VALIDATION & VERIFICATION REPORT
FOR THE
SECOND CREDITING PERIOD AND
FIRST MONITORING REPORT OF VCS
PROJECT 618,

CONVERSION OF SF₆ TO AN
ALTERNATIVE COVER GAS IN
MAGNESIUM PRODUCTION IN EATON
RAPIDS, MI AND STRATHROY, ON

Project Title	Conversion of SF ₆ to an Alternative Cover Gas in Magnesium Production in Eaton Rapids, MI, and Strathroy, ON
Report Title	Validation & Verification Report for the Second Crediting Period and the First Monitoring Report of VCS Project 618 of “Conversion of SF ₆ to an Alternative Cover Gas in Magnesium Production in Eaton Rapids, MI, and Strathroy, ON”
Version	Version 1
Report ID	Visit 1482377
Verification Period	01-January-2017 to 31-October-2017
Client	3Degrees Group, Inc.
Pages	38
Date of Issue	26-March-2018
Prepared By	NSF International
Contact	789 N. Dixboro Street, Ann Arbor, MI 48105 USA, +1-734-769-8010, sustainability@nsf.org ; www.nsf-sustainability.org
Approved By	Michael DeBusschere
Work Carried Out By	John C. Shideler, PhD

Molecular formula of perfluoro-2-methyl-3-pentatone

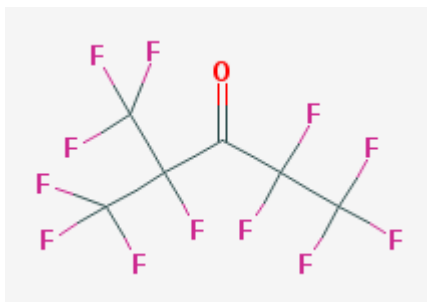
11	CR	Please justify the product equivalence of Novec (dodecafluoro-2-methyl-3-pentanone) and perfluoro-2-methyl-2-pentanone in sections 2.3 and 4.1 (GWP _{Novec}) of the PD.	PD, p. 12, sec. 2.3; AM0065 p.2; Novec Product Information sheet from 3M (Novec name.pdf)	3M identifies the chemical formulation of Novec as "dodecafluoro-2-methyl-3-pentanone," or $\text{CF}_3\text{CF}_2\text{C}(\text{O})\text{CF}(\text{CF}_3)_2$, which is not referenced in AM0065.	As explained in PD v2: Perfluoro-2-methyl-3-pentanone, as referred to in AM0065, is chemically identical to Novec 612 fluid, or dodecafluoro-2-methyl-3-pentanone, as referred to in 3M's Product Information sheet. 3M references the condensed structural formula for dodecafluoro-2-methyl-pentanone as $\text{CF}_3\text{CF}_2\text{C}(\text{O})\text{CF}(\text{CF}_3)_2$, which can also be written as the molecular formula of C6F12O. The National Institutes of Health's Open Chemistry Database cites perfluoro-2-methyl-3-pentanone as the chemical name of C6F12O (https://pubchem.ncbi.nlm.nih.gov/compound/Perfluoro_2-methyl-3-pentanone_#section=Top). The chemical structure shown on this page is the same as the condensed structural formula for dodecafluoro-2-methyl-3-	Clarification accepted, issue closed.

#	Type	Finding/Clarification	Ref.	Audit Evidence	Responsible Party Action	Lead V/V Conclusion
1	CR	Please clarify why 3M's product sheet chemical description of Novec-612, $\text{CF}_3\text{CF}_2\text{C}(\text{O})\text{CF}(\text{CF}_3)_2$, should not be used instead of $\text{C}_2\text{F}_5\text{COC}_3\text{F}_7$.	Monitoring Report, p. 3, section 1.1	3M identifies the chemical formulation of Novec as "dodecafluoro-2-methyl-3-pentanone," which is not referenced in AM0065.	See v. 2	This issue is addressed in the validation findings and has been clarified to our satisfaction. The issue is closed.
2	CR	Please clarify why two different reporting thresholds are cited in the last two paragraphs of the Sustainable Development section 1.10 (p. 5)	Monitoring Report, p. 5, section 1.10	The general reporting threshold under Part 98 is 25,000 MT for a facility; please explain why the 50,000 MT figure is applicable.	See v. 2	This issue is addressed in the validation findings and has been clarified to our satisfaction. The issue is closed.

NSF Finding. On the basis of the evidence reviewed, NSF has concluded that Novec™ 612 is chemically identical to the perfluoro-2-methyl-3-pentatone cover gas specified in AM0065.
